P93-163

- REQUEST:
- A. Variance to allow tandem parking for an existing 19,200 square foot, two-story, mixed-use building on 0.44± developed acres in the General Commercial (C-2) zone; and
 - B. Variance to allow 51% compact parking for an existing mixed-use building.

LOCATION: 2724-2730 J Street (SW Corner 28th & J Streets)
Assessor's Parcel Number: 007-0111-007,008,009,010
Central City
Sacramento Unified School District
Council District 3

Exhibit B
Planting Plan

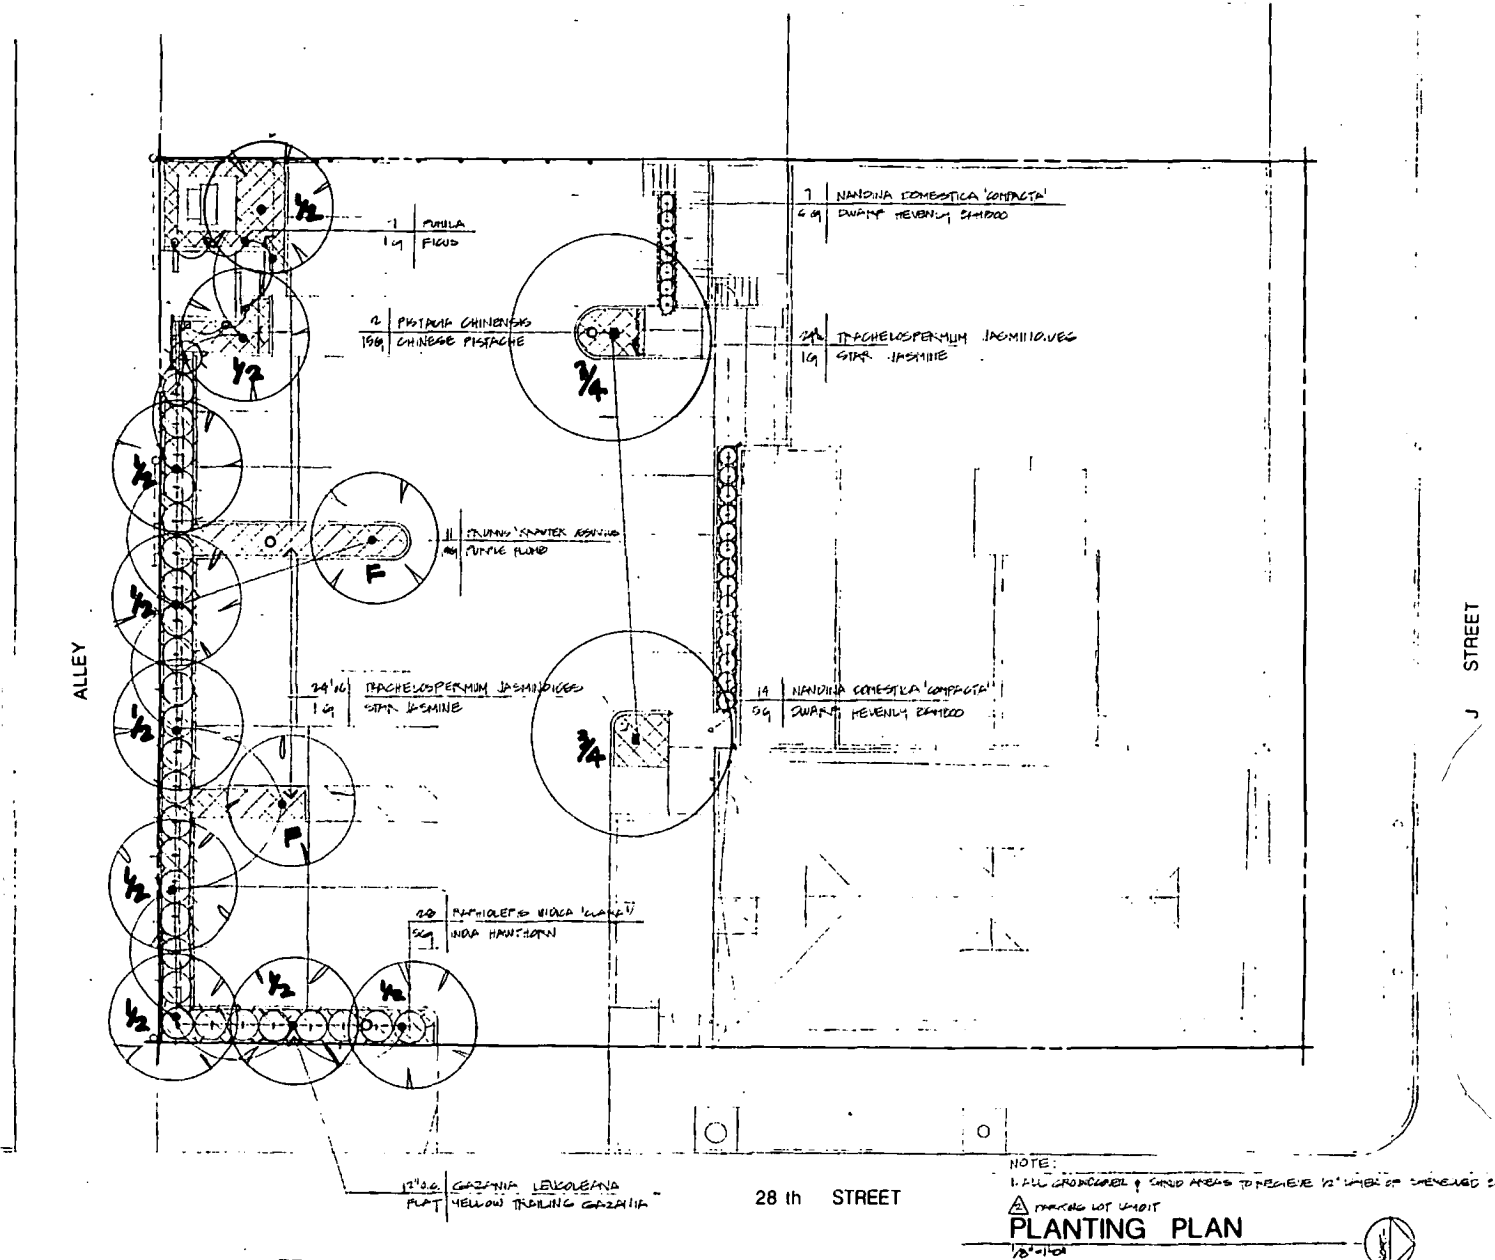
Landscaping. The proposal includes constructing planter areas next to the public alley and in areas near the existing buildings. In addition to shrubbery, the planters will accommodate new trees which will serve to meet the City's standard shading requirement for new parking lots (see attached Planting Plan). The City Arborist has reviewed the revised plans and has indicated that removal of one of the existing palm trees which is located in the path of the proposed driveway may be removed subject to a tree removal permit.
